**Review of the Revised Plan for  
Off-Site Treatment of Newport  
Chemical Agent Disposal Facility's  
Caustic VX Hydrolysate at DuPont  
Secure Environmental Treatment  
Facility in Deepwater, New Jersey**

**A Report to Congress**

**Department of Health and Human Services  
Centers for Disease Control and Prevention**

**July 2006** - *Corrected Version*

Figure 1. Removal Efficiency of the DuPont Revised Process

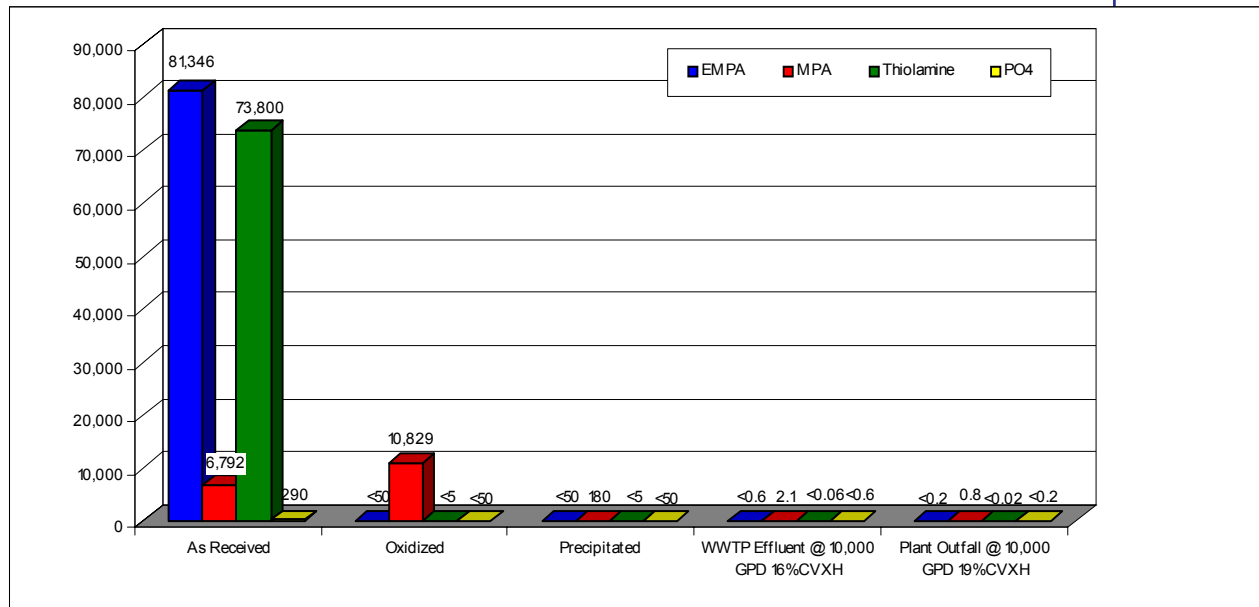
- The DuPont combined pretreatment studies demonstrate that 16% VX loaded CVXH DIC, DCC, and DIC/DCC stabilized hydrolysate can be effectively treated to remove phosphonates (EMPA and MPA) before biotreatment. The results of the testing are shown in Figure 1 (5).
